AMENDMENT OF SOLICITATION

1. AMENDMENT/MODIFICATION NO. <b>0007</b>		2. EFFECTIVE DATE <b>APR 01, 2003</b>	
3. ISSUED BY  DEPARTMENT OF THE ARMY, BALTIMORE DISTRICT CORPS OF ENGINEERS P.O. BOX 1715 BALTIMORE, MARYLAND 21203-1715

6. ACCOUNTING AND APPROPRIATION DATA (If required) <b>WYOMING VALLEY LEVEE RAISING – PHASE IIB WILKES-BARRE &amp; HANOVER TOWNSHIPS, PENNSYLVANIA</b>

SKETCH SK C-2 31 MAR 03

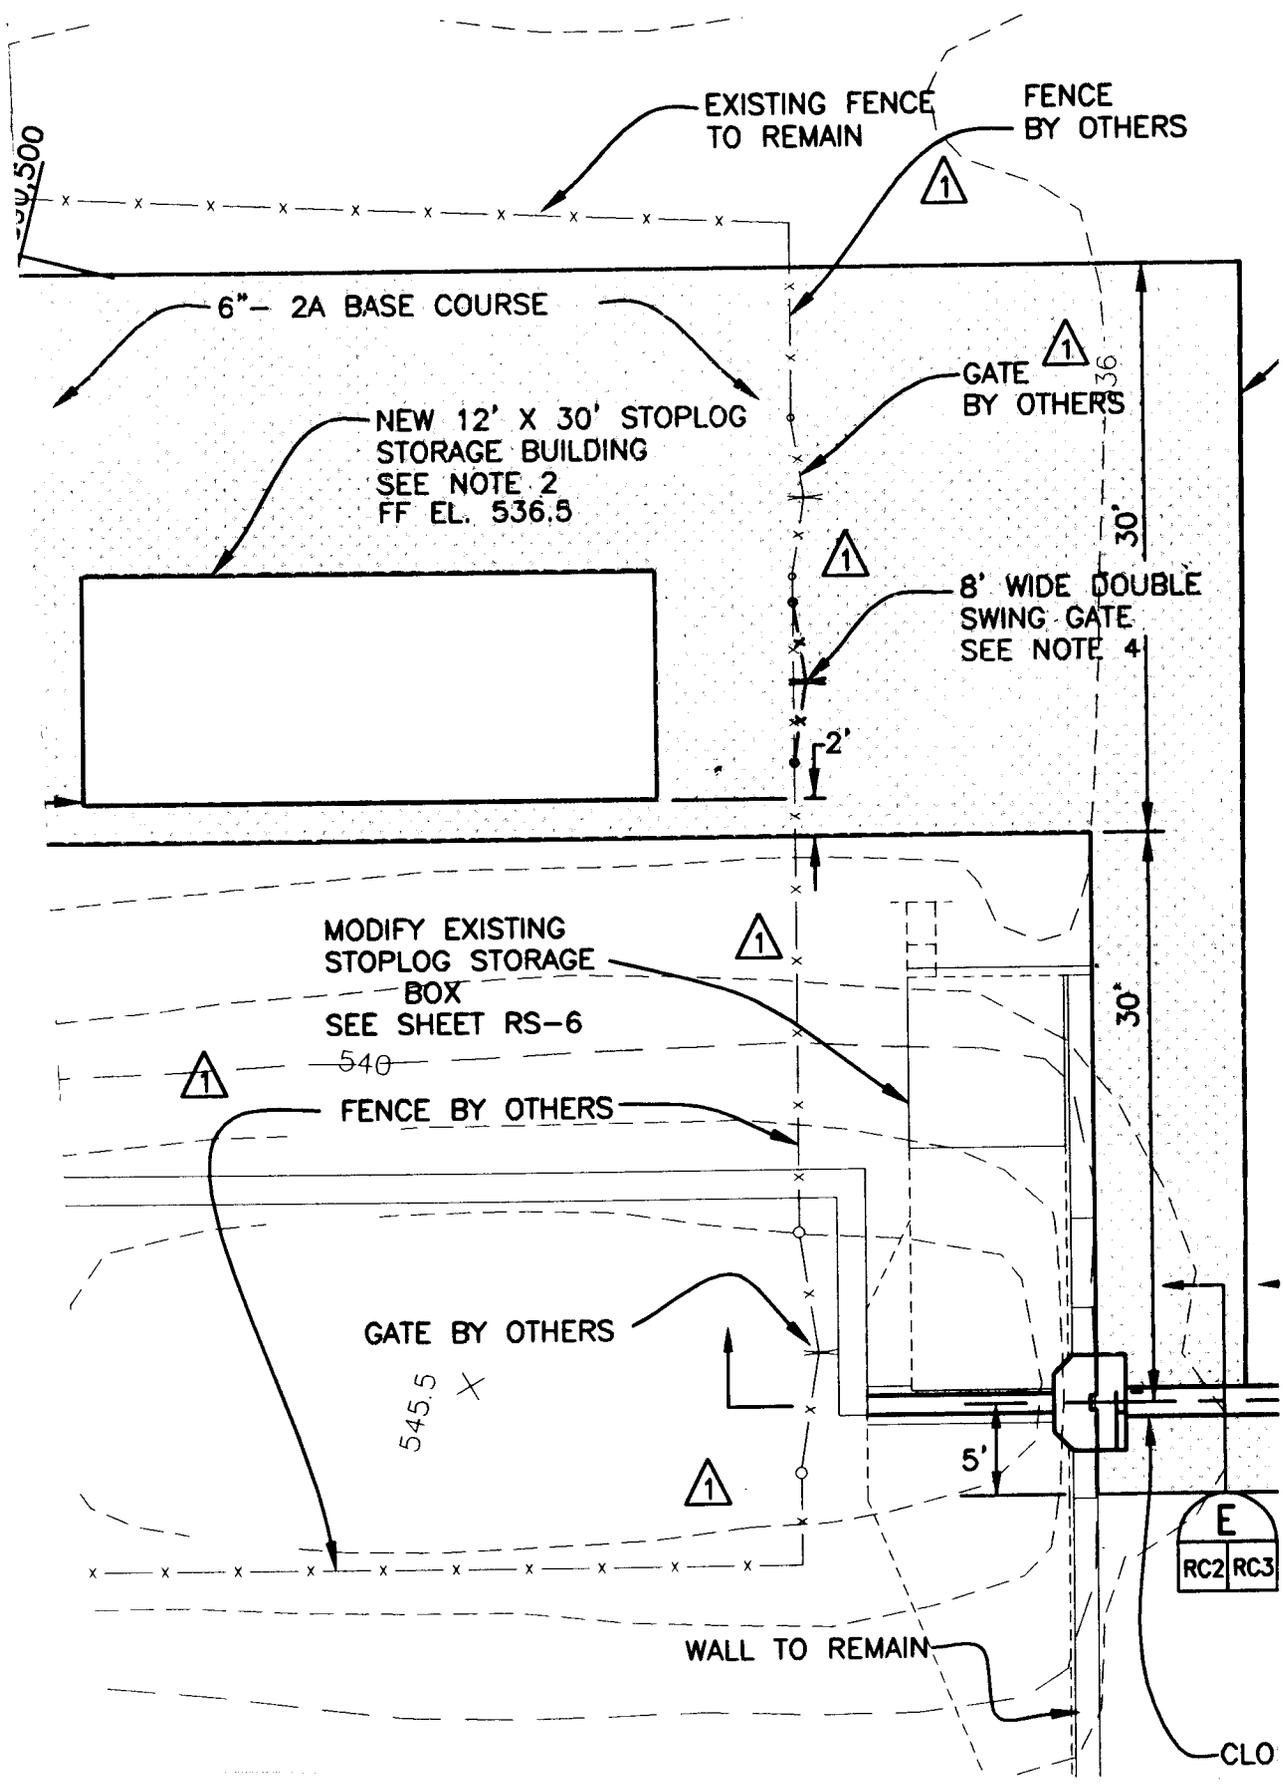
(a) Revise fence and labels in accordance with attached Sketch SK C-2, dated 31 Mar 03.
